INDESIT company

Model type:
AV61EU

Commercial code:
F029890

Notices

1180250 Exploded views

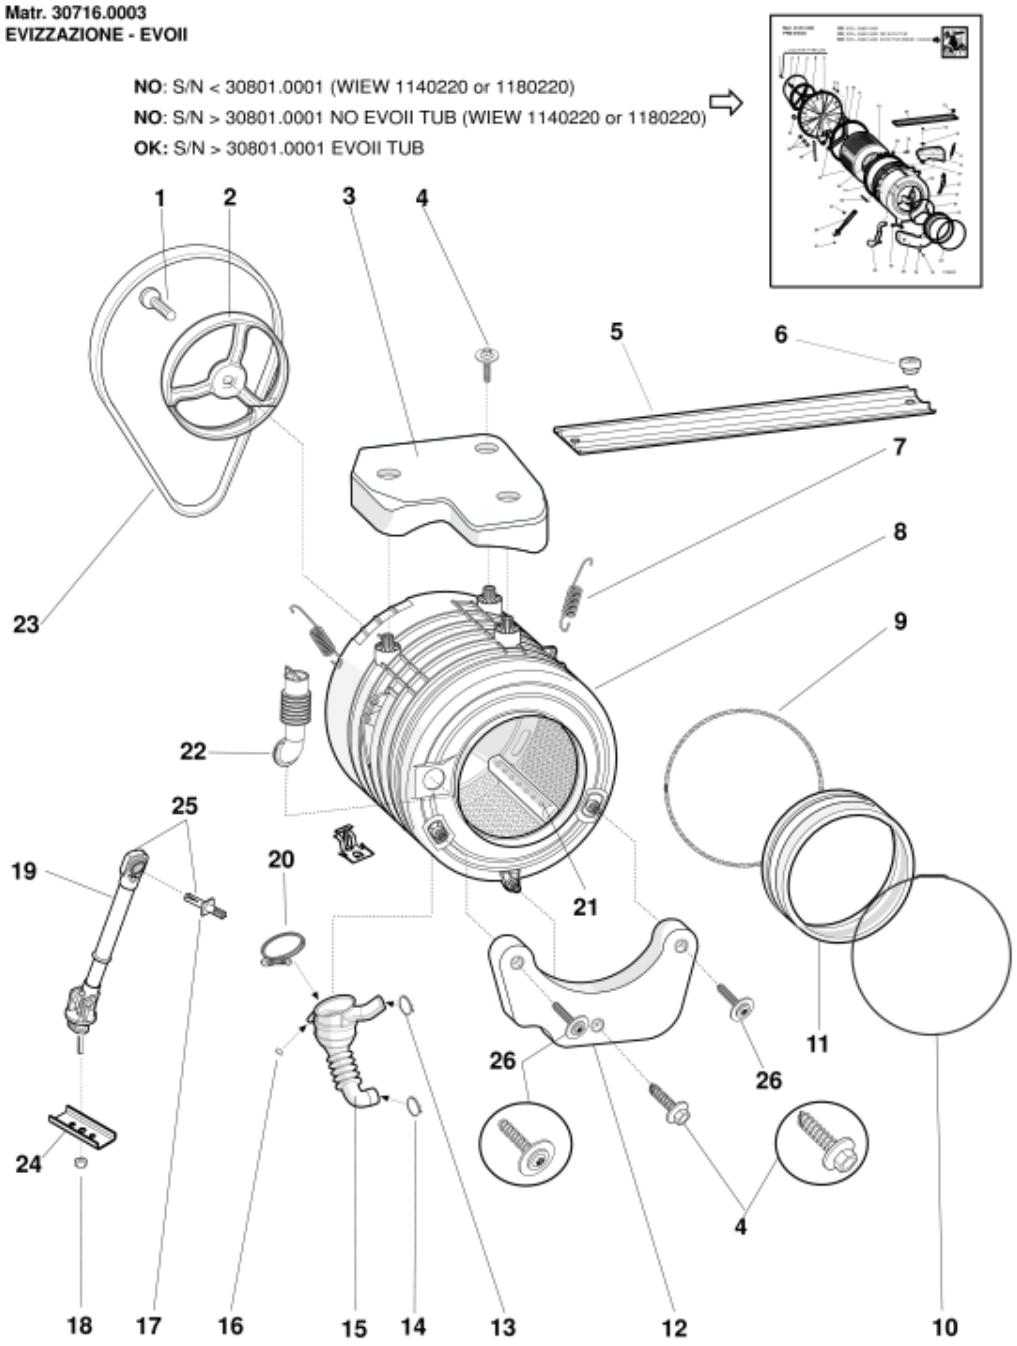
n1040377: Modification of 280 mm - 400/600 rpm transmission unit.

Appliances from serial number 51011.0001 have been equipped with a new transmission unit affecting the motor, belt and pulley; these parts are not interchangeable individually with the premodification parts.

n1040417: Modification of shock absorbers and expanders on Teverola washing-machines.

From serial no. 60403.0001, new shock absorbers and expanders have been introduced.

New P/Ns for 400 rpm models
C00140699 - Poly-V1232J4 / 1245J4 belt;
C00097268 - Pulley D=280 mm H=15 mm;
C00059561 - Motor 2/12 230 V 50 Hz;

400 rpm premodification P/Ns
C00081785 - Poly-V 1247J4 / 1262J4 belt
C00097267 - Pulley D=210 mm H=15 mm;
C00075892 - Motor 2/12 230 V 50 Hz;

New P/Ns for 600 rpm models
C00140700 - Poly-V1232J4 / 1245J4 belt;
C00097268 - Pulley D=280 mm H=15 mm;
C00059686 - Motor 2/16 230 V 50 Hz;

600 rpm premodification P/Ns
C00081730 - Poly-V 1106J4 belt
C00097267 - Pulley D=210 mm H=15 mm;
C00066087 - Motor 2/16 230 V 50 Hz;

New codes:
C00144540 - shock absorber 120N
C00118593 - expander

Premodification codes
C00055039 - shock absorber 120N
C00055037 - expander

The new parts can be used (not separately) also on all appliances equipped with shock absorbers 120N - C00055039; in this case both shock absorbers / expanders must be replaced: kit C00144546, composed of two new shock absorbers, two new expanders and two plates for cabinet is available.

Fig . 001

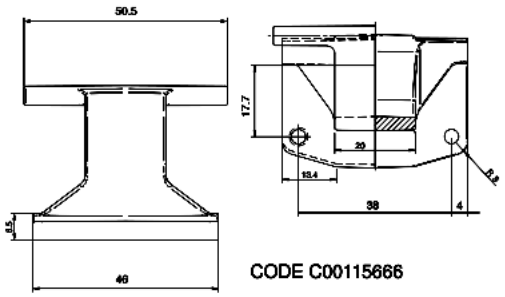
n1040349: Introduction of 150° Zamac hinge on Ariston 46 models.

From serial no. 50207.0001, all Ariston models produced in the Teverola factory (see table 001 attached) with industrial code (given on the rating plate) starting with 46, have been equipped with a Zamac hinge with 150° opening angle, code C00115666 (see Fig.001).
This modification has involved the introduction of the following items:

Code C00115670 - Complete door EVOII 150° white 27 with standard glass;
Code C00115674 - Complete door EVOII 150° white 27 with long glass;
Code C00115667 - EVOII body for 150° hinge white 27;

The premodified items are not interchangeable separately with the modified ones.

Code C00110133 - Complete door EVOII Standard 180° white 27 standard glass;
Code C00092157 - Complete door EVOII 180° white 27 long glass;
Code C00096193 - EVOII body for 150° hinge white 27;

The hinge code C00064541 continues to be used on the build-under models produced in the Comunanza factory.
